# Authorized Field Change

AFC G-04909 Revised

**Subject:** International Ride Optimize Suspensions (IROS) Installed in RE Bus Models Built in the Conway Assembly Plant Before June 16, 2004 Require the IROS System Upgraded to the Current Design Level

**Figure 1 Measure Horizontal Dimension Between Arrows**

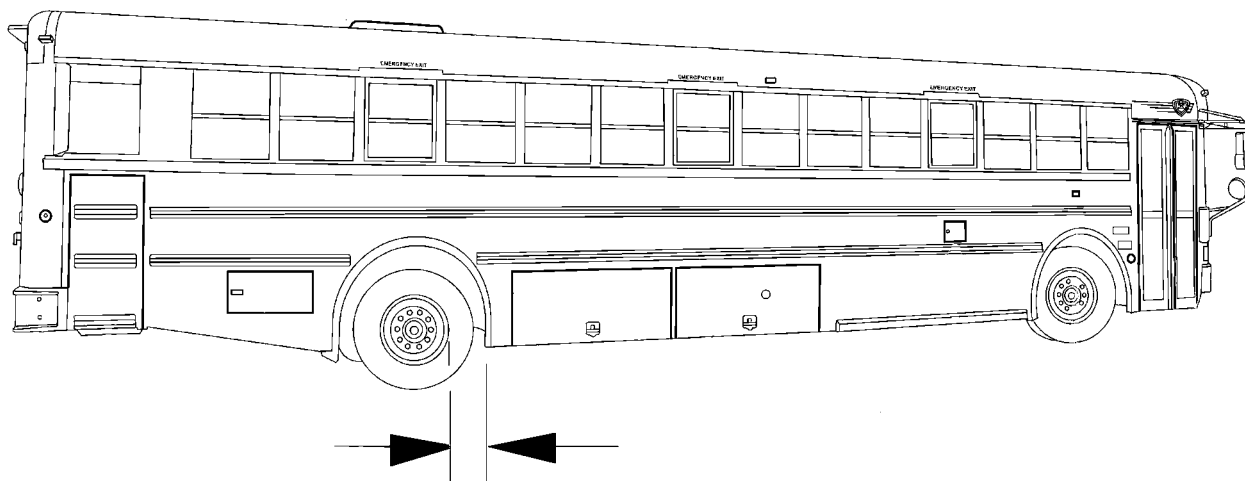
1. Measure and record the rear axle alignment on **both sides** of the bus by measuring the horizontal distance between the wheel rim and the inner edge of the wheel well as shown in Figure 1. Place a mark on the rim and the wheel well to indicate the two points used to make the measurement. Use a level to insure the measurement points remain in the same plane during both before and after measurements.

**Figure 2 Remove Ride Height Control Rod and Valve Assembly**

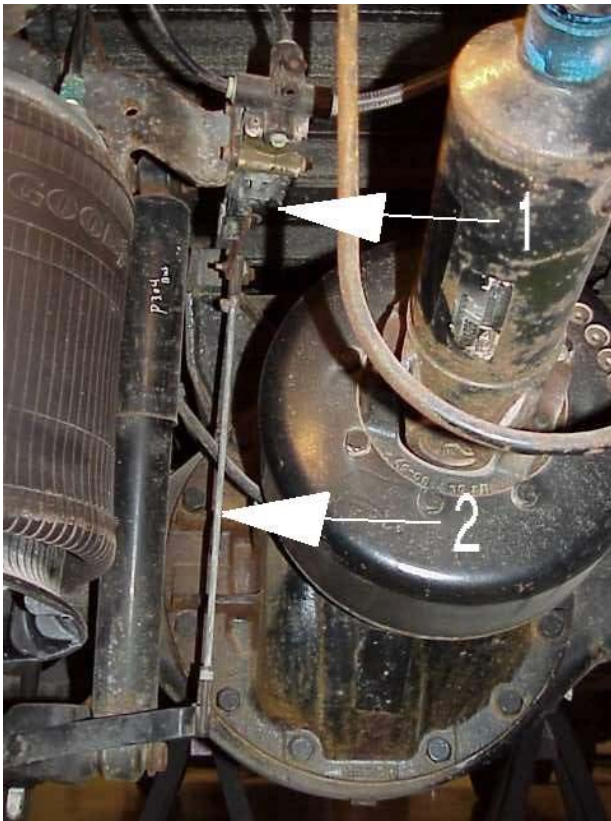
2. Raise the chassis rear end and support from the frame rails with floor stands.
3. Drain the vehicle air system.
4. Remove the IROS ride height control rod and ride height valve assembly (Figure 2).

1. Ride Height Valve
2. Ride Height Control Rod
5. Disconnect air lines from the IROS air springs.
6. Remove mounting bolts and the air spring (Figure 3).

**Figure 7 IROS Components**

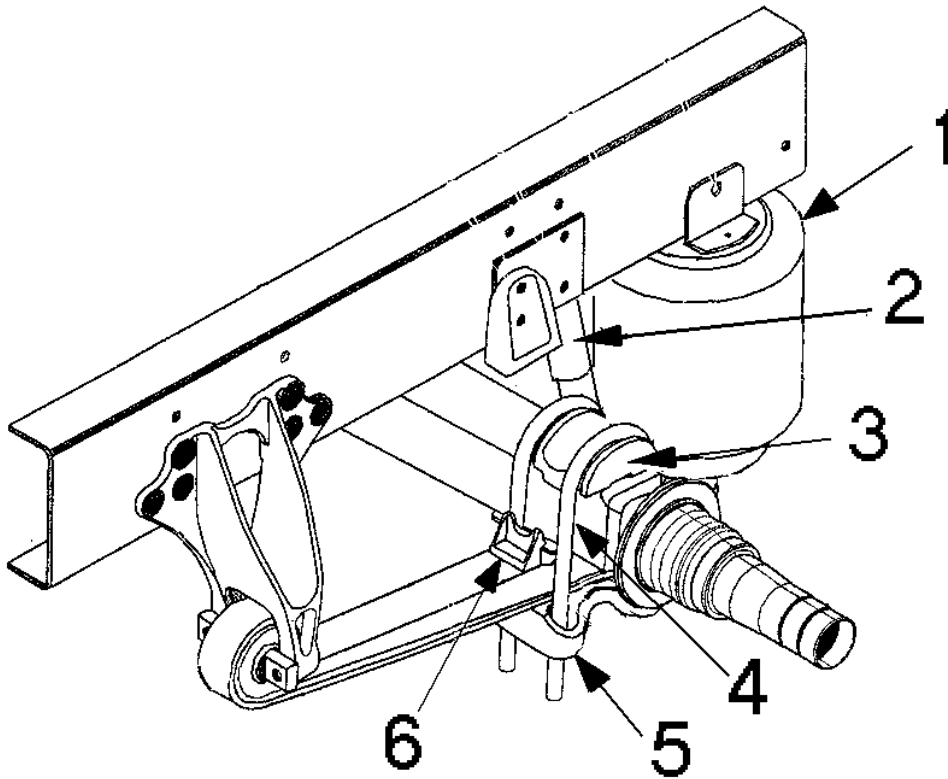
12. Use a jack to raise the new IROS spring into position, use a new axle seat (Figure 7, Item 6) from the kit, between the IROS spring and the axle, reuse the top u-bolt plate (Figure 7, Item 3) and install a new lower u-bolt plate (Figure 7, Item 5). Install new u-bolts, washers and nuts (Figure 7, Item 4) from the kit and at this time tighten only enough to hold the axle in position.

13. Install a new shock absorber (Figure 7, Item 2) from the kit. Tighten to 135 to 165 Lbf-ft (183 to 224 Nm).
14. Install a new air spring (Figure 7, Item 1) from the kit. Tighten mounting nuts to 40 to 60 Lbf-ft (54 to 81 Nm).
15. Repeat Steps 4 – 14 for the opposite side then continue to Step 16.
16. Install the new ride height valve and rod from the kit.
17. Reconnect the air lines to the ride height valve.
18. Reconnect the air lines to the ride height valve and air springs.
19. Remove floor stands and jack.
20. Start the engine to charge the air system and check for air leaks.
